SUBMITTAL SUMMARY REPORT WaiverSTA-000807-2026

PLAN NAME: Melody Preserve/32515	LOCATION: 7945 SW 80TH ST OCALA,
APPLICATION DATE: 05/21/2026	PARCEL: 35300-000-15
DESCRIPTION: We are requesting a waiver to allow for the Type 'E' buffer along the north property boundary to utilize a fence in lieu of vegetation. The buffer will remain 20' width. The existing vegetation along the north property boundary within the adjacent Liberty Village residential subdivision is mature and will not allow for the buffer to adequately grow as intended. Additionally, we request the fence to continue within the Type 'A' buffer on the property line. The adjacent storage facility currently utilizes a fence on their property boundary so the landscaping will not be a benefit to that parcel.

DEVELOPMENT REVIEW COMMITTEE WAIVER REQUEST FORM

TYPE 'E' BUFFER

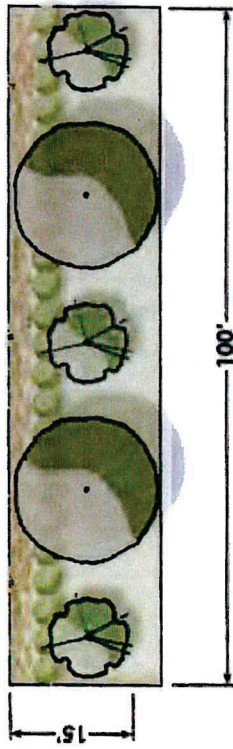
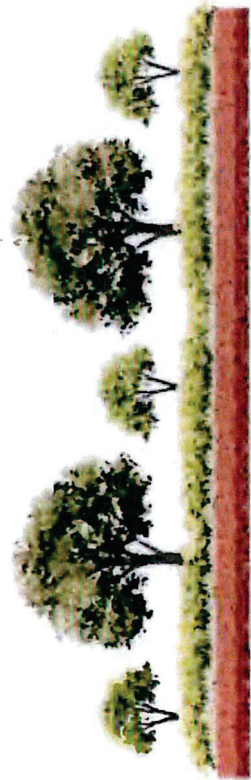
Reason/Justification for Request (be specific): We are requesting a waiver to allow for the Type 'E' buffer

along the north property boundary to utilize a fence in lieu of vegetation. The buffer will remain 20' width. The existing vegetation along the north property boundary within the adjacent Liberty Village residential subdivision is mature and will not allow for the buffer to adequately grow as intended. Additionally, we request the fence to continue within the Type 'A' buffer on the property line. The adjacent storage facility currently utilizes a fence on their property boundary so the landscaping will not be a benefit to that parcel.

SUBMITTAL	STARTED	DUE	COMPLETE	STATUS
OCE: Waiver Request Review v.1	05/28/2026	06/08/2026	06/03/2026	Approved
